Access Compliance Report Public Rights-of-Way (RR Crossings)

Intersection ID: 18726	Main Street: TYVOLA_RD	Location: N/A
ADA ID: 0B7EF8EA37B2	Overall Compliance: No	Severity Score: 0.0
Codes/Mitigation Info/Possible Solution		Field Measurements/Component Compliance

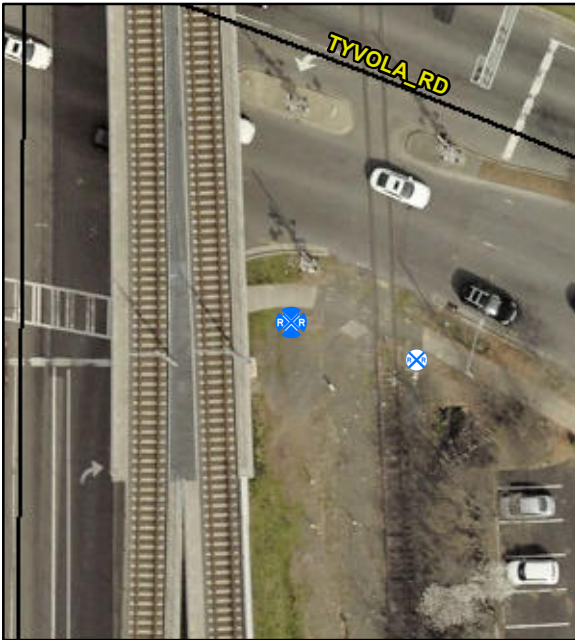
**Install Detectable Warning System.
Provide Pedestrian Gate. Remove &
Replace Walking Surface Adjacent
to Rail.**

Compliance	Description	Data
No	DWS Provided?	No
N/A	DWS Contrast?	N/A
N/A	DWS Width (in)	N/A
N/A	DWS Length (in)	N/A
N/A	DWS Offset (in)	N/A
No	Pedestrian Gate?	No
N/A	DWS Outside Gate?	N/A
N/A	Rail Type?	Freight
No	Flangeway Gap (in)	3.0
Yes	Sidewalk Width (in)	71.0
